MILL PARK, BALLAN ROAD SAFETY AUDIT

PROPOSED MASTERPLAN

Client: Moorabool Shire Council

Report Reference: 20461T

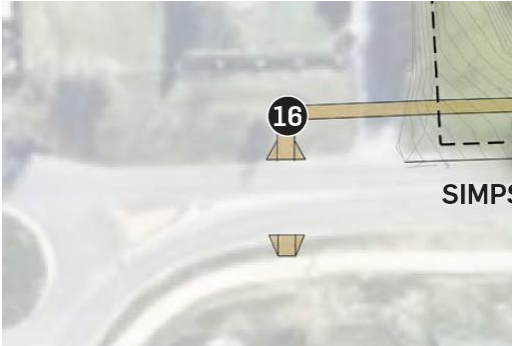
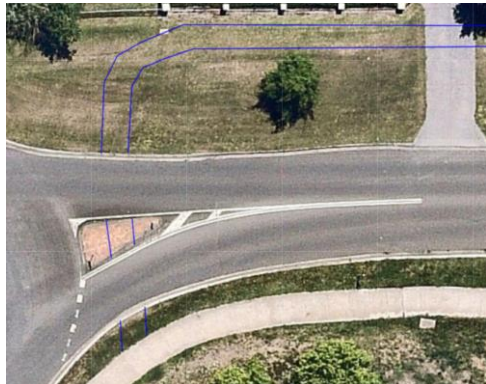
Audit Findings	Recommendation/s	Rating	Project Manager																																								
			Accept? Yes/No	Reasons/Comments																																							
<div>4. Pedestrian crossing point (eastern)</div> <div>It is proposed to install a pedestrian crossing point near the Simpson Street / Simpson Street intersection – refer Item 15 below:</div> <div></div> <div>This will connect with an existing footpath that provides access to the park from the east, south-east and north-east. The river prevents access from occurring elsewhere along Blackwood Street to the east, and so we envisage this crossing point will be relatively heavily used.</div> <div>Noting the high speeds at which some drivers were observed to travel at when coming down the hill from the east, there is a heightened risk of collision between vehicles and pedestrians over what is a relatively wide crossing point (approx. 8.4m).</div>	<div>Supporting Treatment</div> <div>Consider any or all of the following treatments:</div> <div><div>1. Reduction of the speed limit to 50km/h.</div><div>2. Installation of pedestrian warning signs.</div><div>3. Construction of a pedestrian refuge to provide a safer two stage crossing (will require the crossing point to be shifted slightly west and the adjacent indented parking bay to be removed, in order to maintain satisfactory vehicle access to the crossover of No. 43 Simpson Street).</div></div> <div></div>	<div>IMPORTANT</div> <div>Likelihood: <i>Occasional</i></div> <div>Severity: <i>Serious</i></div> <div>Level of Risk: <i>High</i></div> <div>

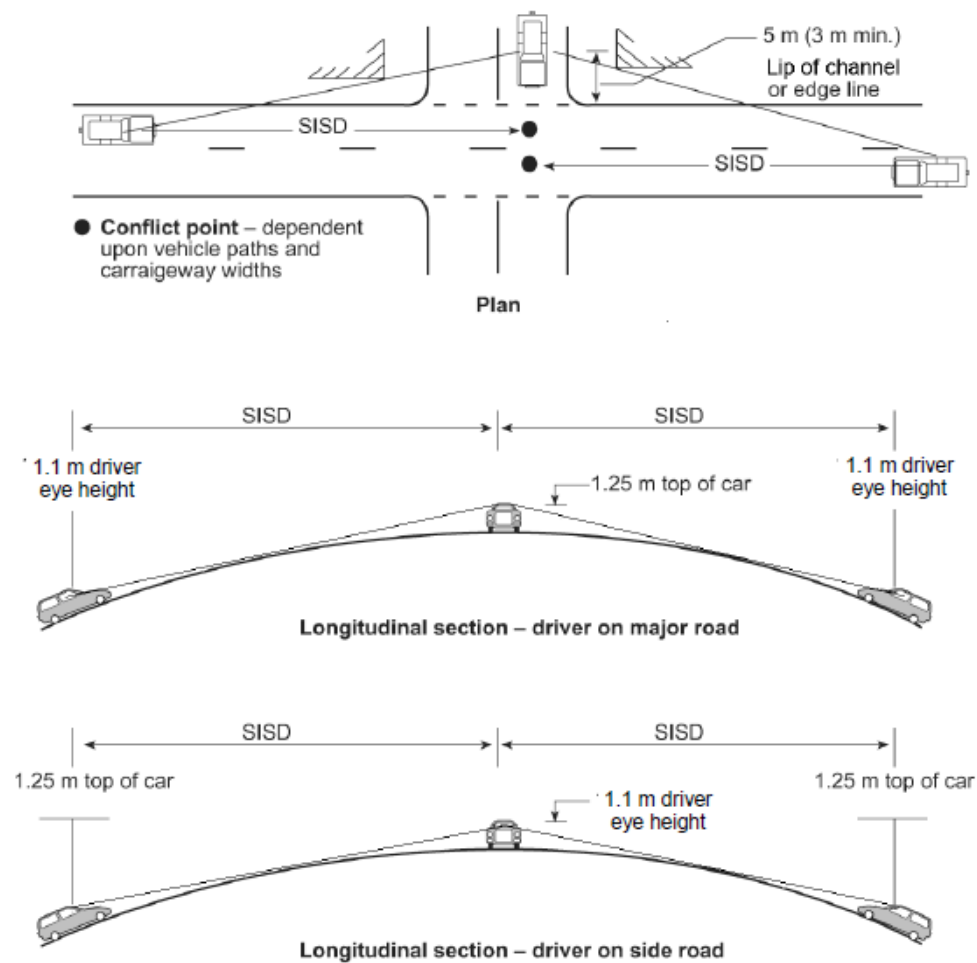
Audit Findings	Recommendation/s	Rating	Project Manager																																								
			Accept? Yes/No	Reasons/Comments																																							
<div>5. Pedestrian crossing point (western)</div> <div>It is proposed to install a pedestrian crossing point near the Simpson Street / Stead Street roundabout – refer Item 16 below:</div> <div></div> <div>This will facilitate access from the west and south along Stead Street.</div> <div>The location, set back approximately 18m from the roundabout exit, raises the risk of collision from drivers exiting the roundabout who will begin to pick up speed. It would be better placed closer to the roundabout, or deleted altogether with a pedestrian refuge island provided to the east instead.</div>	<div>Supporting Treatment</div> <div>Consider any of the following treatments:</div> <div>1. Construct a pedestrian refuge within the existing roundabout splitter island, with connecting pram ramps; or</div> <div></div> <div>2. Construct a pedestrian refuge island further east.</div> <div></div>	<div>IMPORTANT</div> <div>Likelihood: <i>Occasional</i></div> <div>Severity: <i>Serious</i></div> <div>Level of Risk: <i>High</i></div> <div>

Figure 5 SISD to east from car park access point (Normal Design Domain)

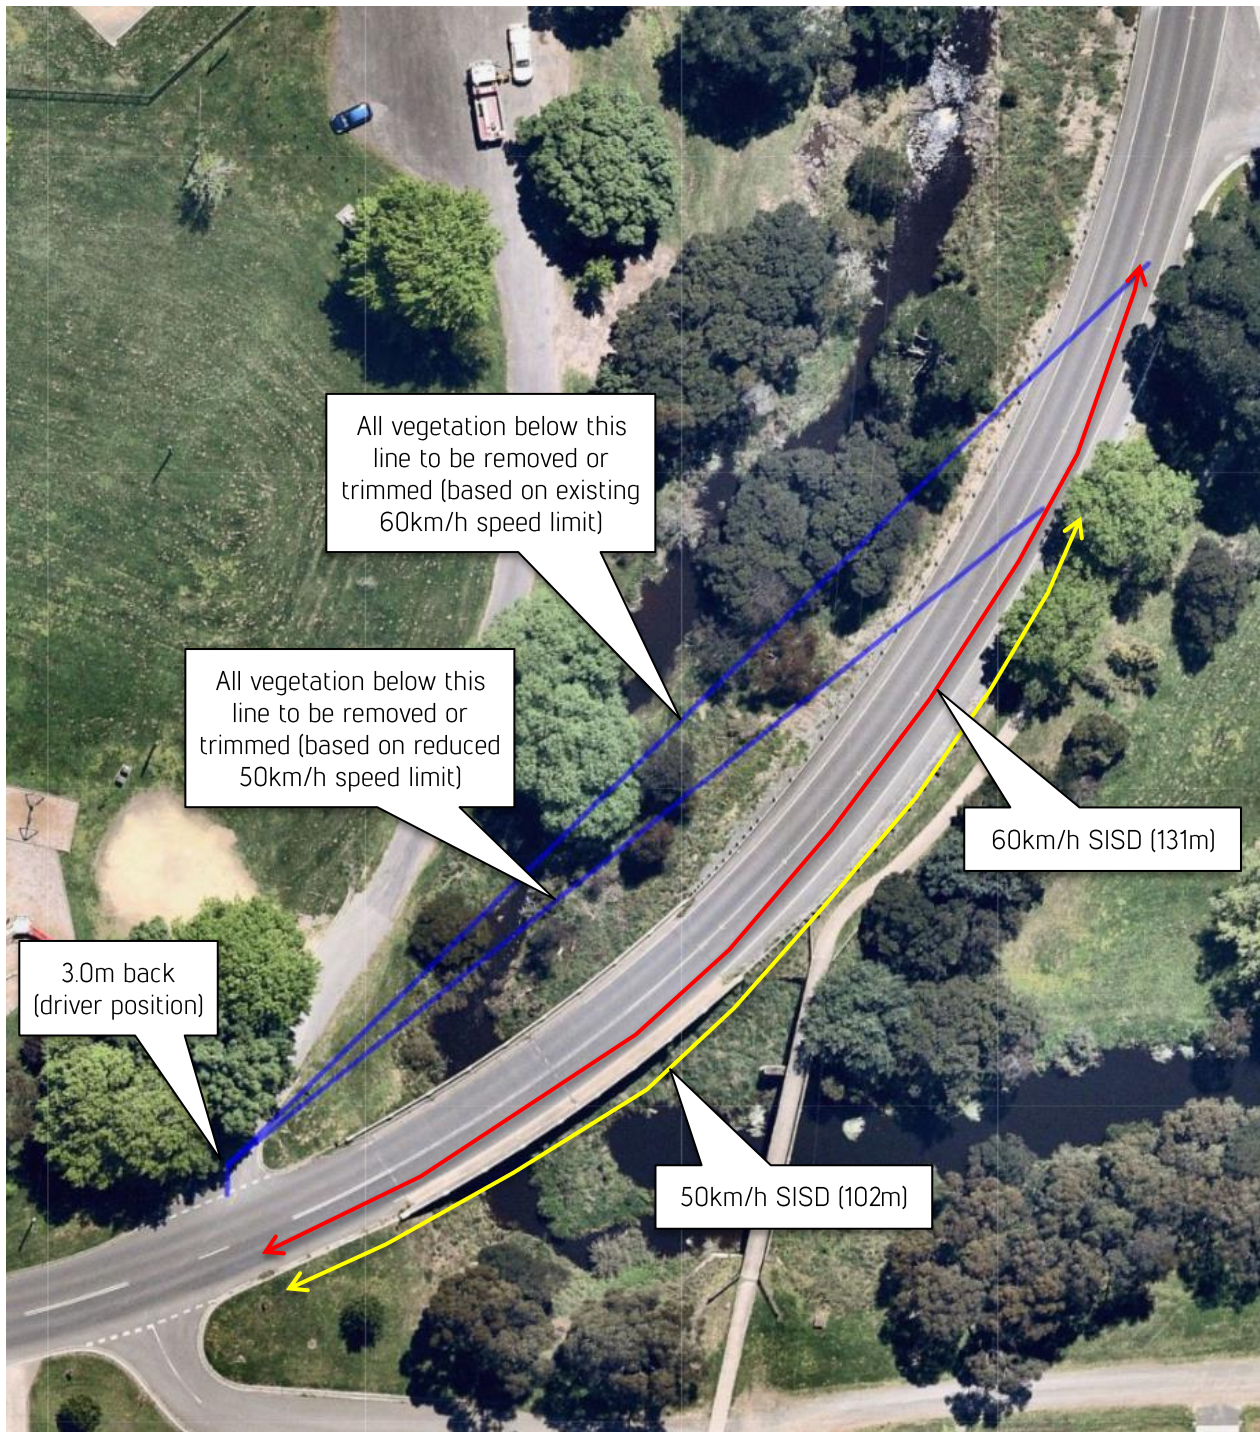
Audit Findings	Recommendation/s	Rating	Project Manager	
			Accept? Yes/No	Reasons/Comments
<p>Note, these are the 'Normal Design Domain' (NDD) requirements that are applicable under most normal circumstances and should be seen as the desirable standard.</p> <p>However, Council could consider adoption of the AustRoads Extended Design Domain (EDD) requirements. These are essentially 'relaxed' standards that may be applied in constrained situations where NDD cannot reasonably be achieved, including existing brownfield areas.</p> <p>The EDD SISD requirements are as follows (including estimated grade corrector factor). Note that existing traffic volumes must be determined.</p> <p>Traffic volume <4000 vehicles per day (two-way)</p> <p>50km/h: 75m 60km/h: 94m</p> <p>Traffic volume >4000 vehicles per day (two-way)</p> <p>50km/h: 82m 60km/h: 102m</p>	<p>If SISD requirements cannot be met due to retention of trees, we recommend that the intersection be relocated further west (although this will also require tree removal).</p>
